STAFF RECOMMENDATION

903 Caruthers Avenue

April 22, 2020

Application: Demolition; New Construction—Infill and Detached Accessory Dwelling Unit

Drawing Title:
 FRONT & LEFT
 ELEVATIONS

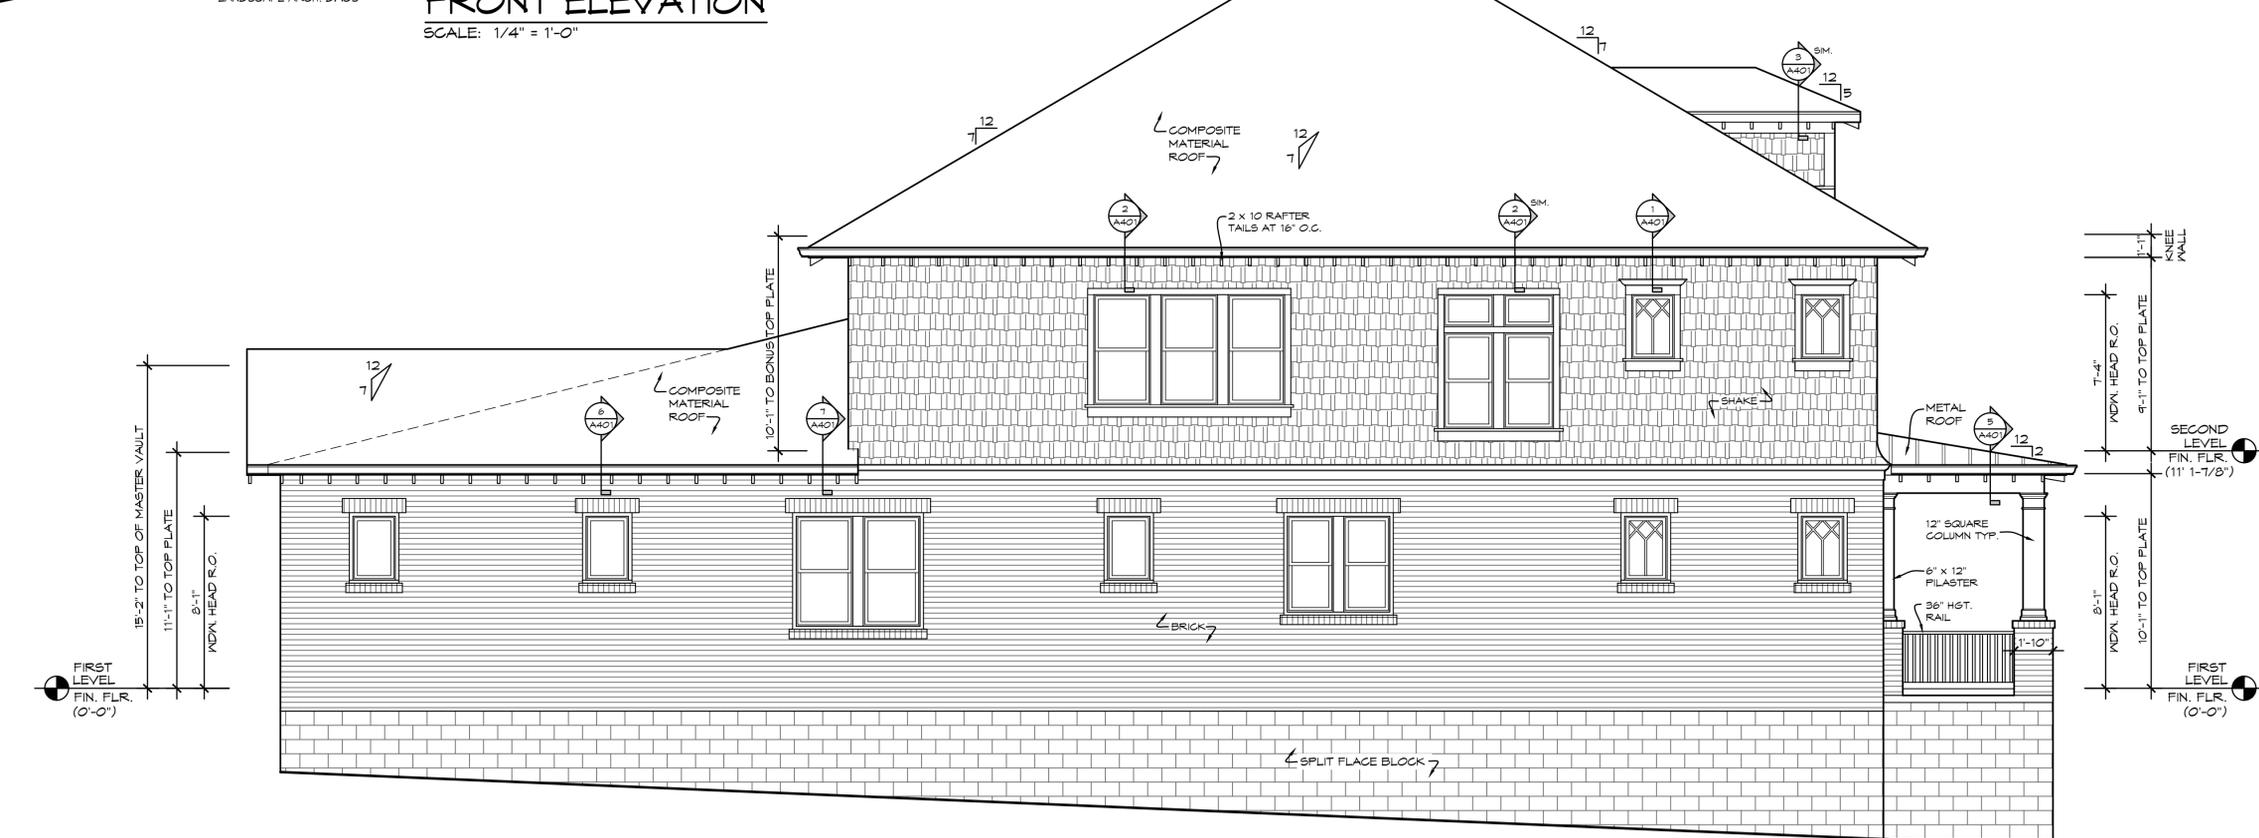
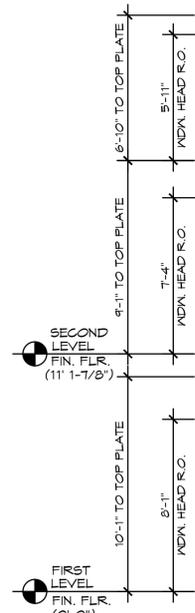
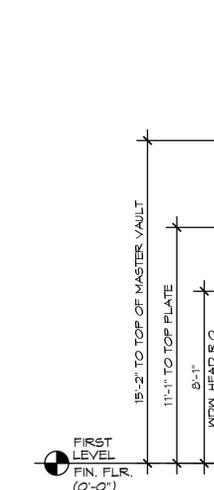
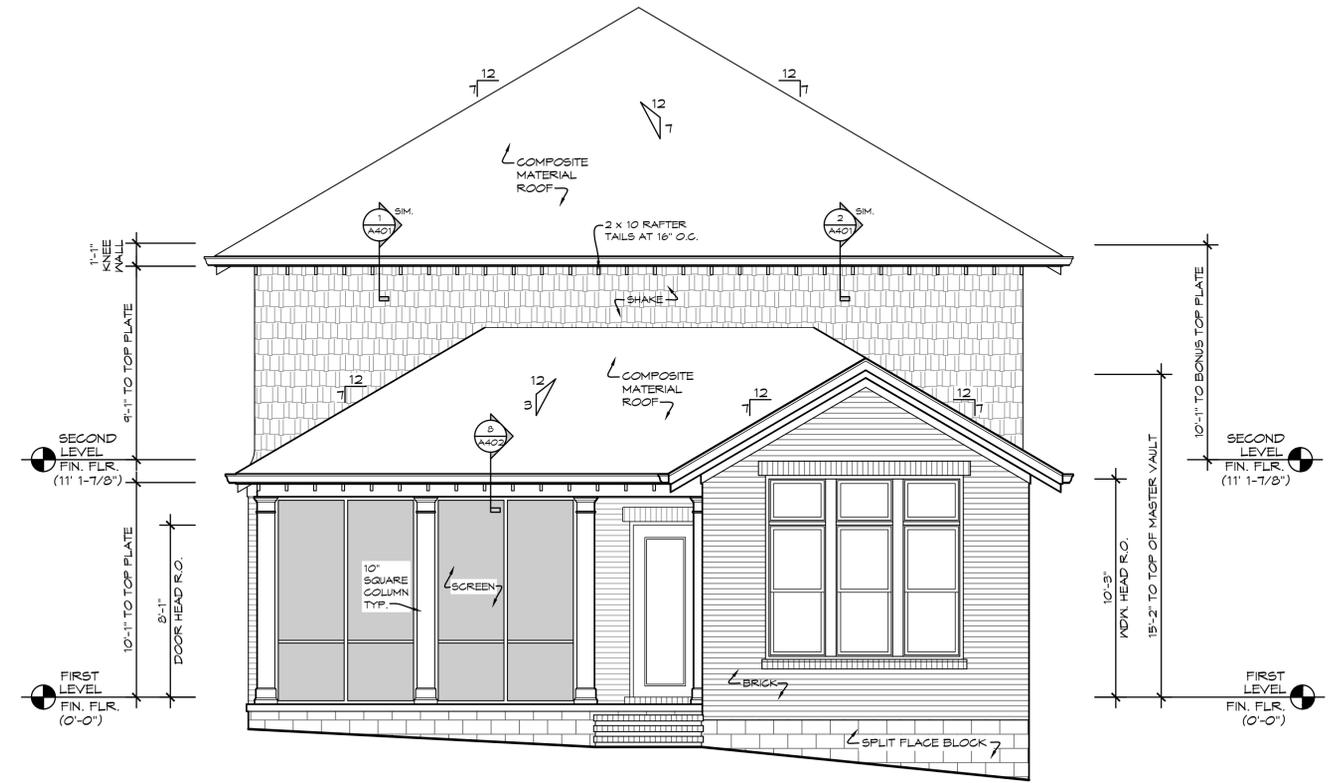
*The porch steps are shown as brick. Brick is not an appropriate material for front porch steps, as historically, steps were wood, concrete, or stone. Staff recommends that the front porch material be concrete, wood, or stone.

Staff recommends approval of a masonry sample, the roof shingle color, the metal roof design and color, the front porch steps, and all windows and doors prior to purchase and installation.

2. The front porch steps be concrete, stone, or wood;
3. Staff recommends approval of a masonry sample, the roof shingle color, the metal roof design and color, the front porch steps, walkway, and all windows and doors prior to purchase and installation;
4. The HVAC shall be located behind the house or on either side, beyond the mid-point of the house.
